Statement of Expert Evidence:
Urban Design

Amendment C123 to the Moreland
Planning Scheme

Prepared by Simon McPherson,
Director, SJB Urban, for Moreland City
Council

27 June 2014

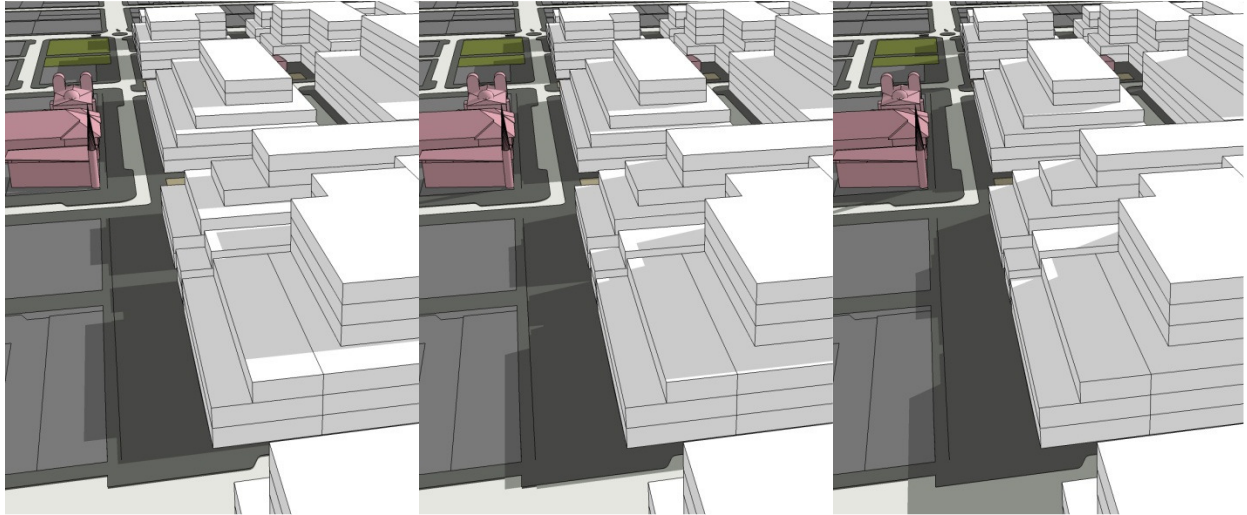
- The built form profiles result in overshadowing exceeding, or not meeting, the requirement in the ACZ Schedule (for sunlight to the southern footpath in winter), by a significant margin, as shown below (Figure 1);

Figure 2: Same view of Victoria Street looking west with dimensions for modified built form profiles, to achieve the requirement for sunlight to the southern footpath (no overshadowing within 2m of southern building line, 12-2pm, 21 June).

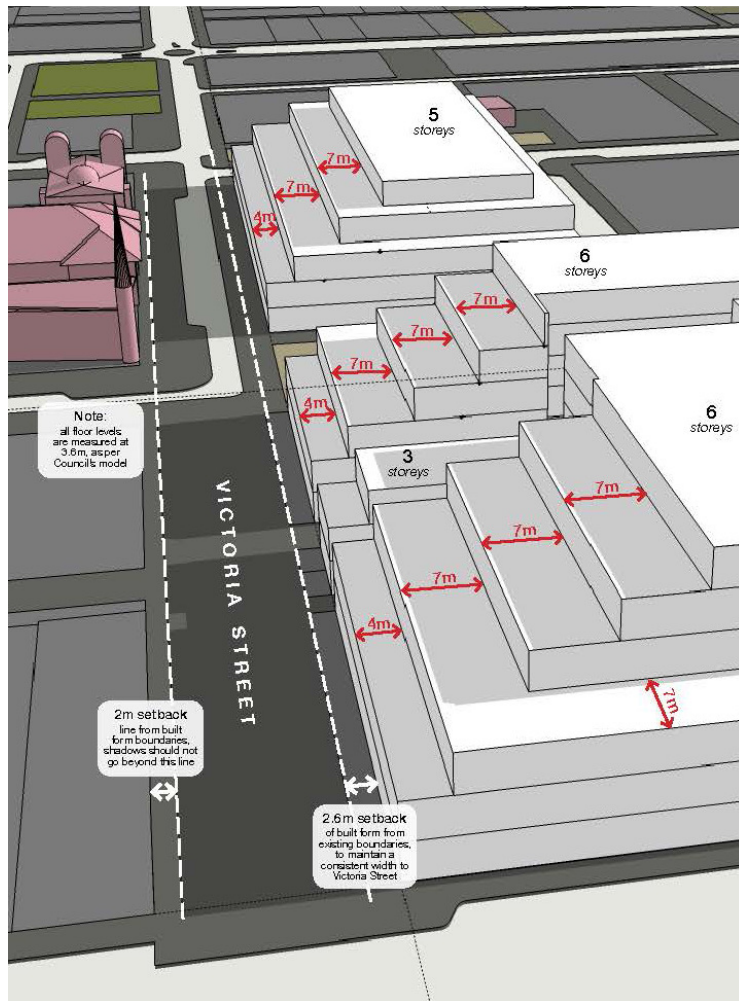
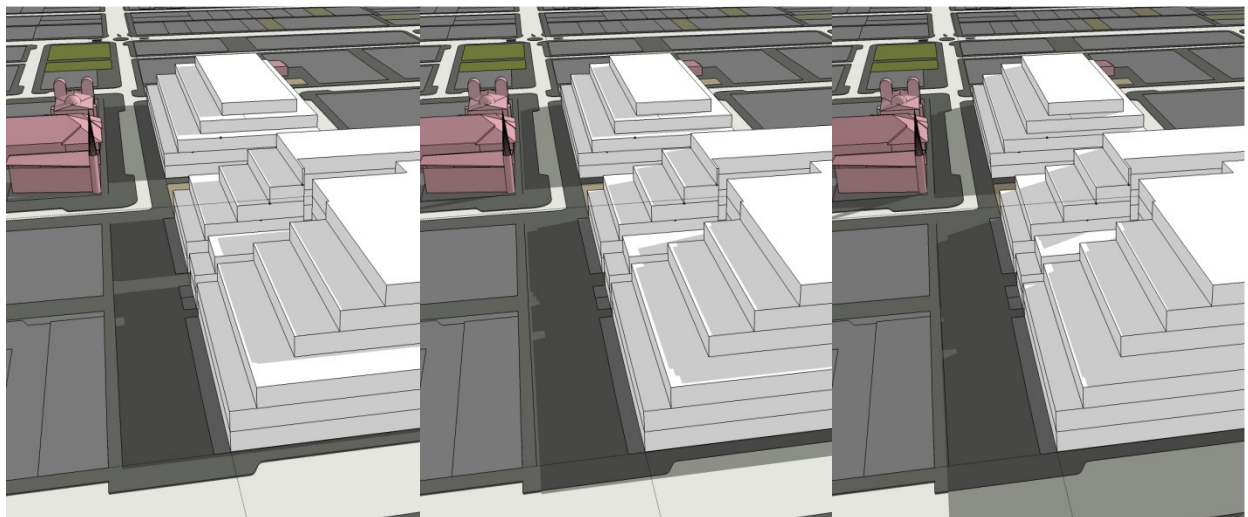
- The 'set-forward' alignment of the built form west of Waterfield Street, relative to that east of Waterfield Street (and so narrowing of the street), based on current subdivision alignments, results in excessive overshadowing beyond the requirements, caused by the 2-storey podium form alone, regardless of upper level setbacks. This suggests that to achieve the stated requirement, a 1-storey street wall would be required, or the building frontage should be set back approximately 2m to align with that to the east of Waterfield Street.
- To achieve the solar access requirement, the overall building heights can be retained, as well as the 2-storey street wall height (noting the point above), but upper level setbacks need to be increased, as shown below Figures 2 and 3).

Based on this testing, it is recommended that the other requirements for solar access to key public realm spaces also be tested and confirmed.
